Plymouth South High School
Plymouth, MA
Ai3 Project # - 1308.00

Addendum #1

June 5, 2015

TRACK LAYOUT
SCALE: 1"=50'

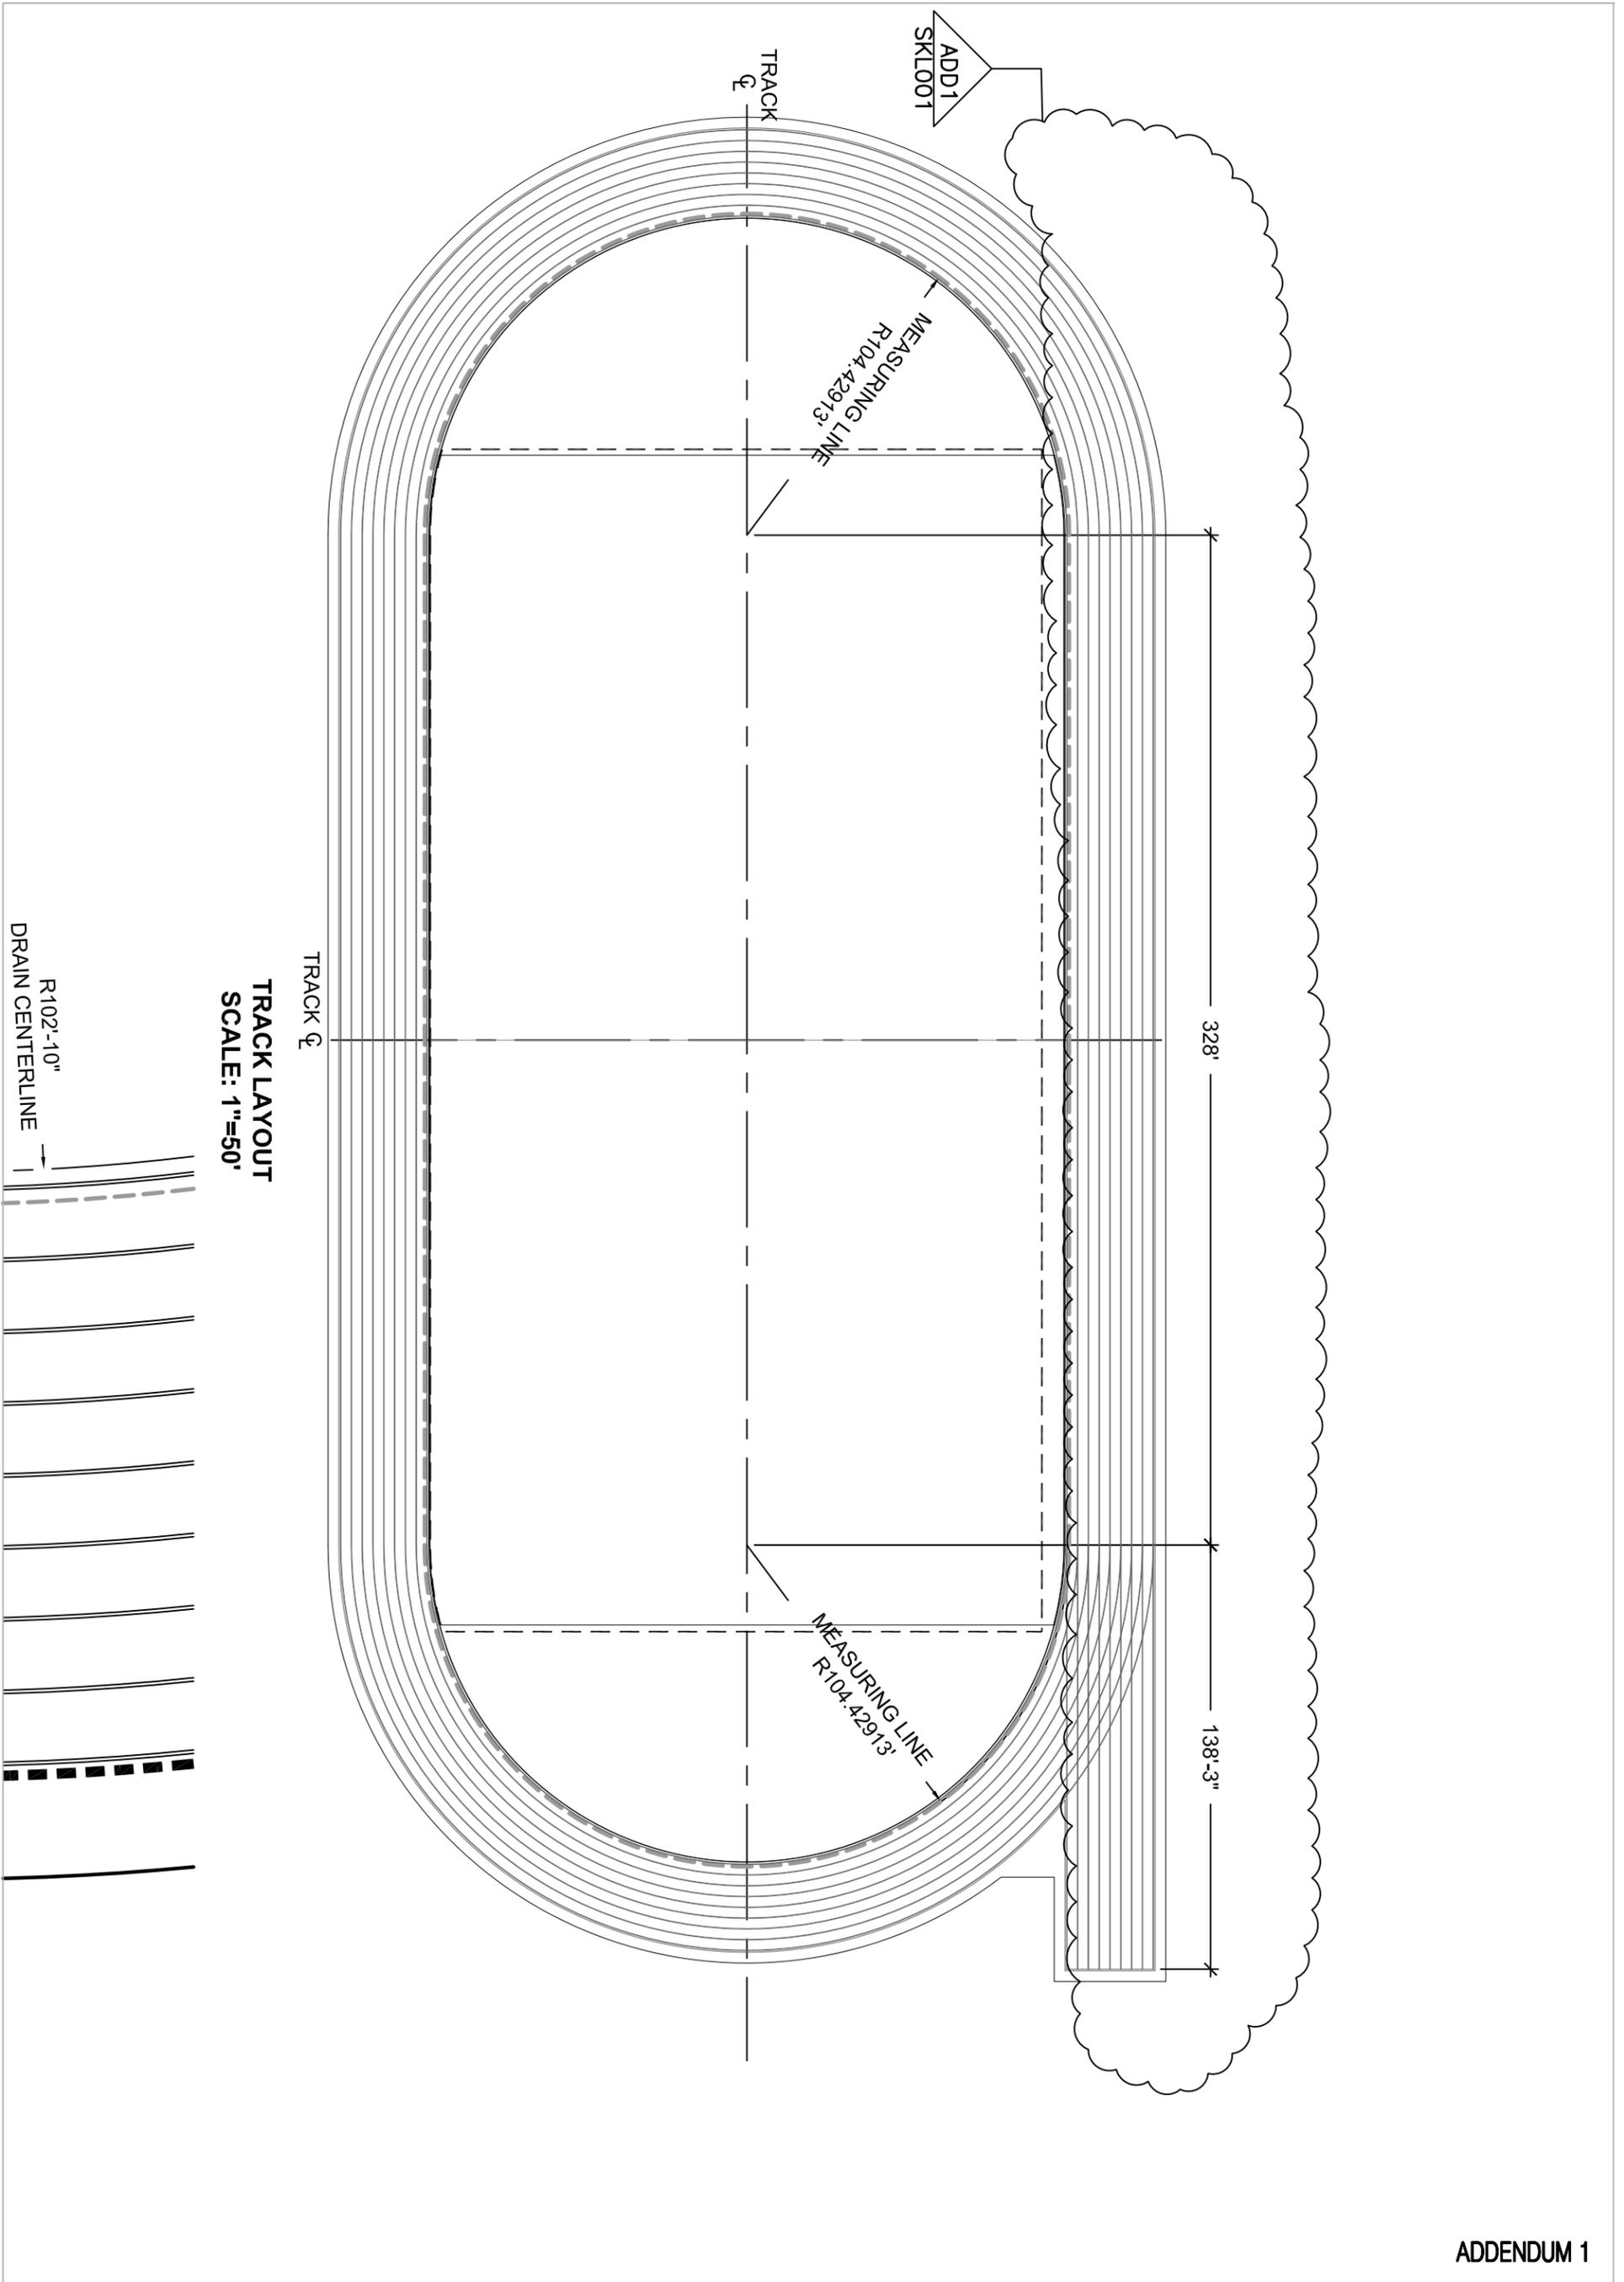
- ADD 1-093 Drawing L3.3 – Landscape Details Plan No. 4
Detail 1 / Track Layout; REMOVE dimension “103'-11”” on the east side of the track in its entirety and REPLACE with dimension “138'-3””

DRAWN BY:	MG	SKFP-001
SCALE:	1/8"=1'-0"	
JOB NO:	1308.00	
DATE:	6/5/2015	
REF DWG:		FP1.11

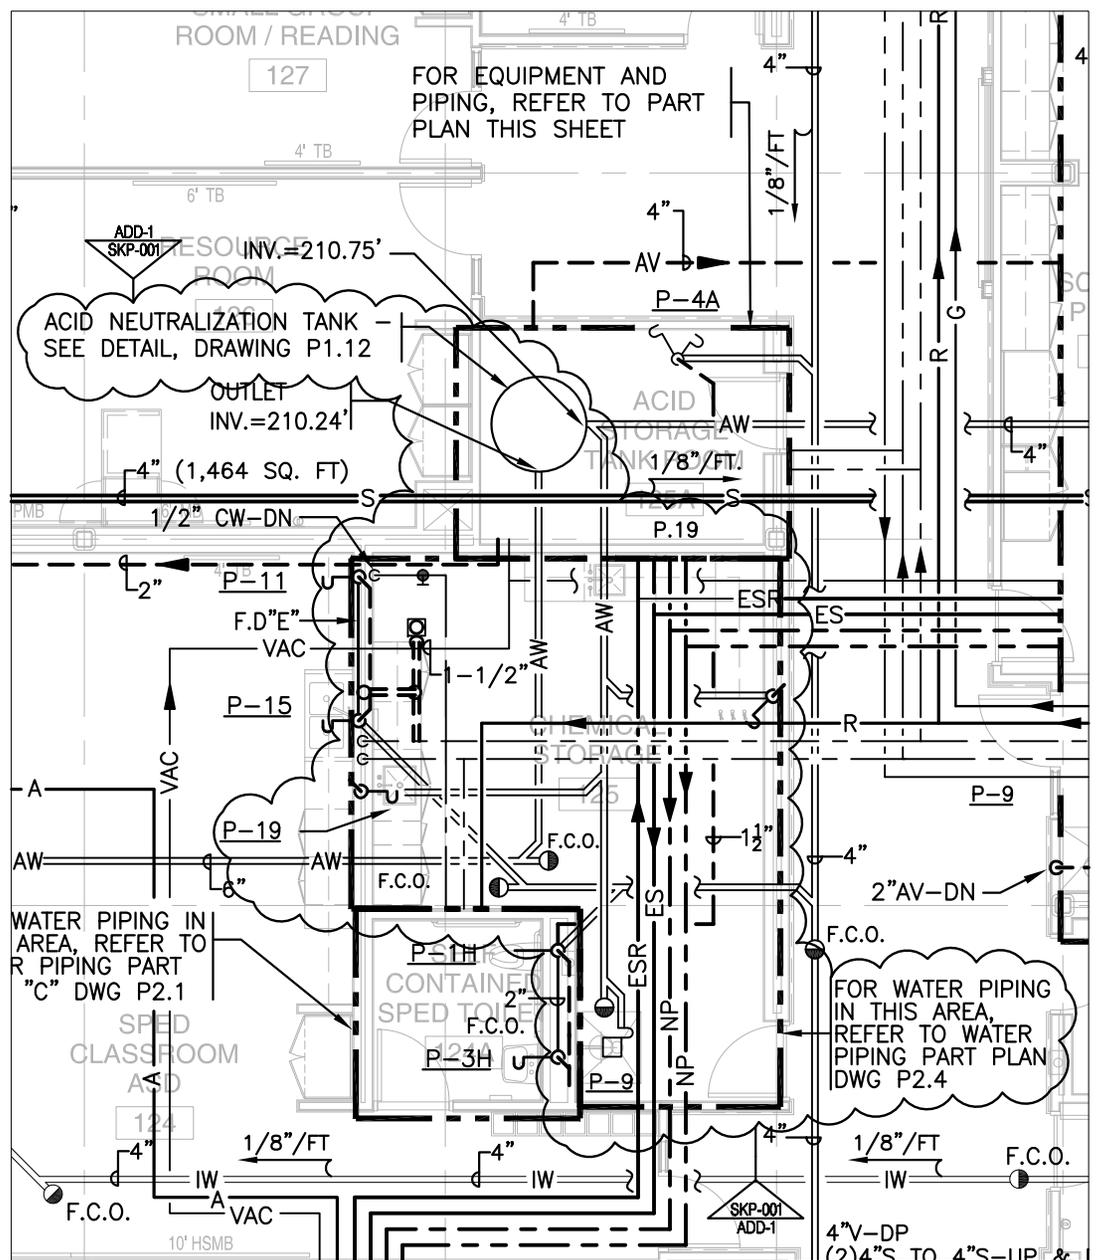
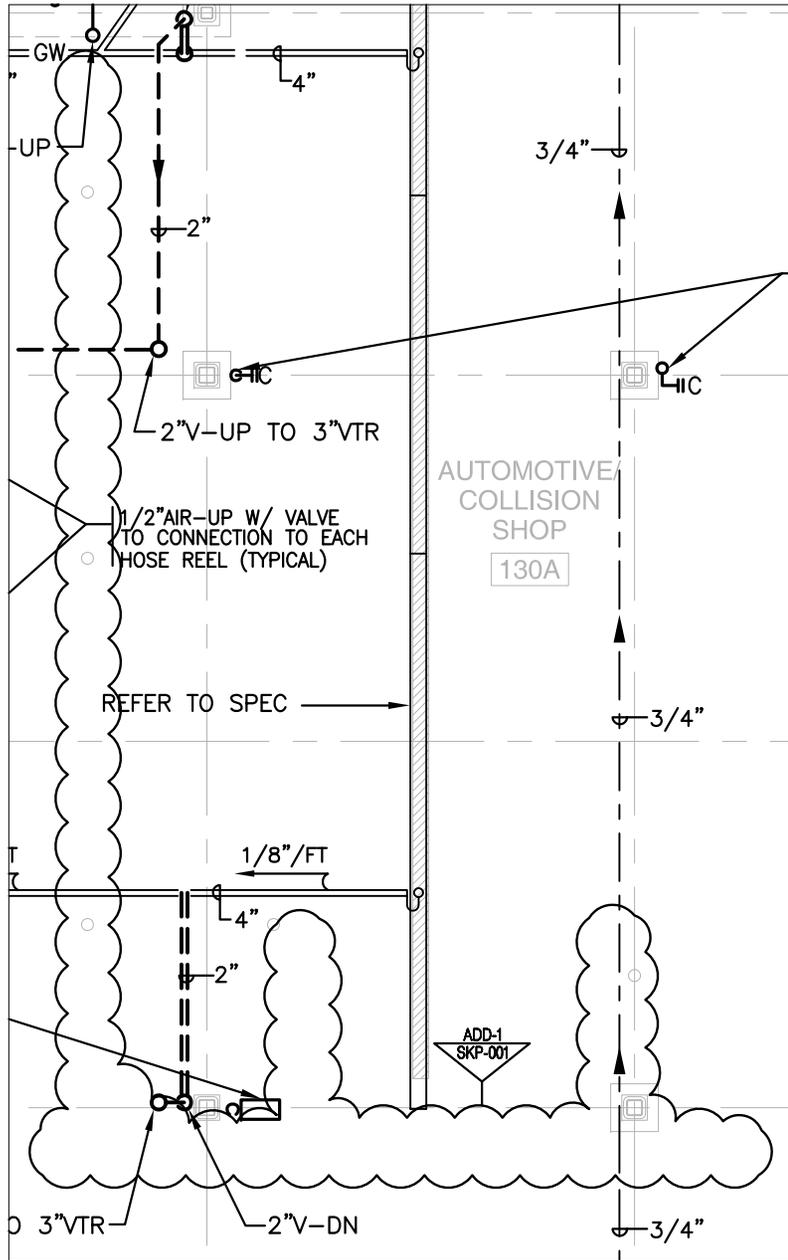
- ADD 1-0144 Drawing FP1.11 – First Floor Plan Zone 1
Construction Shop, student work bay area, REMOVE sprinkler heads and branch piping.

1 ACID TANK ROOM WATER & VACUUM PART PLAN, RM 125 A
 1/4" = 1'-0"

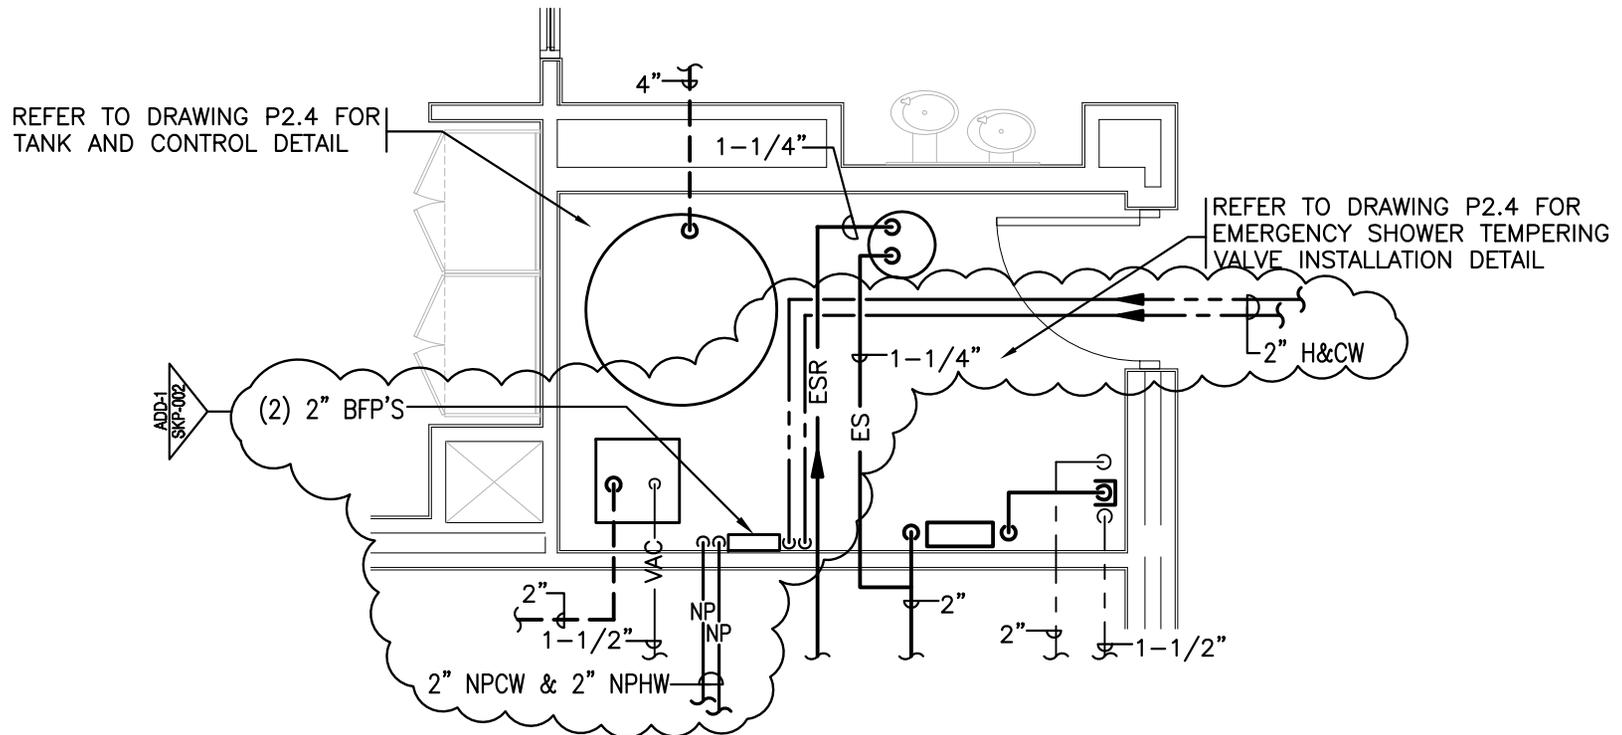
- ADD 1-0145 Drawing P1.12 – First Floor Plan Zone 2
Auto Motive/Collision Shop, REMOVE under slab ductwork.
Chemical Storage, ADD plumbing notes.
Acid Tank Room, ADD plumbing notes.

DRAWN BY:	MG	SKP-003
SCALE:	1/8"=1'-0"	
JOB NO:	1308.00	
DATE:	6/5/2015	
REF DWG:	P1.13

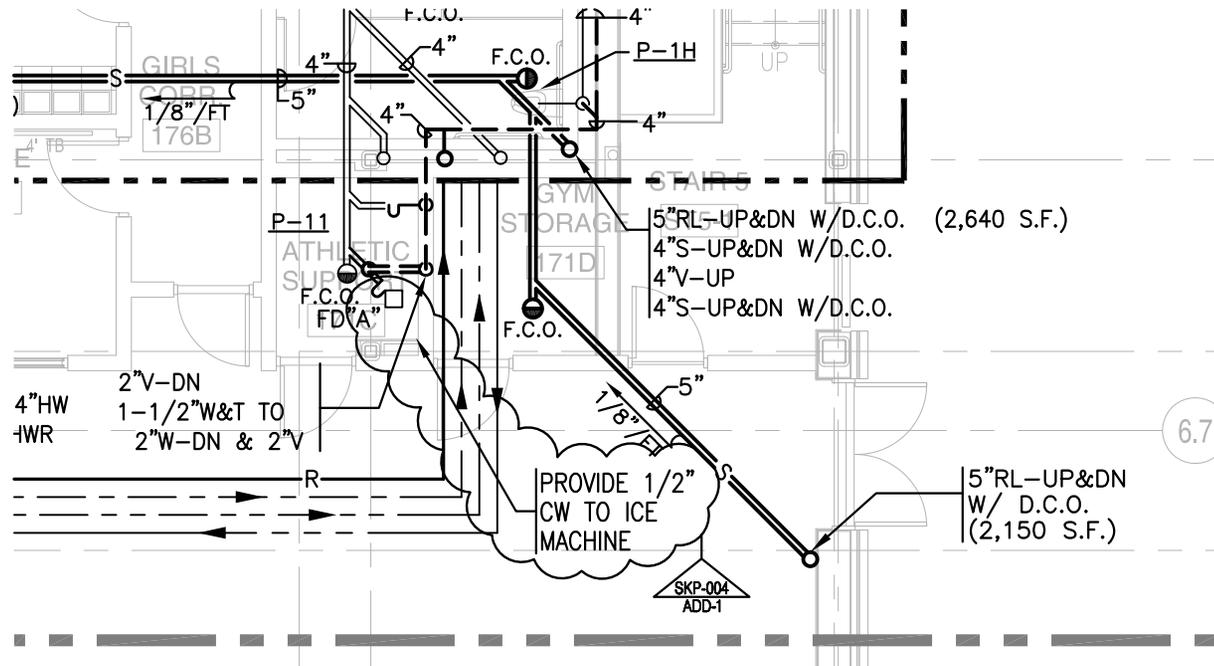
- ADD 1-0146 Drawing P1.13 – First Floor Zone 3
Medical Assisting, Change P-13 fixtures to P-10 fixtures.
- ADD 1-0147 Drawing P1.16 First Floor Plan Zone 6 & 7
Athletic Support, ADD plumbing notes.
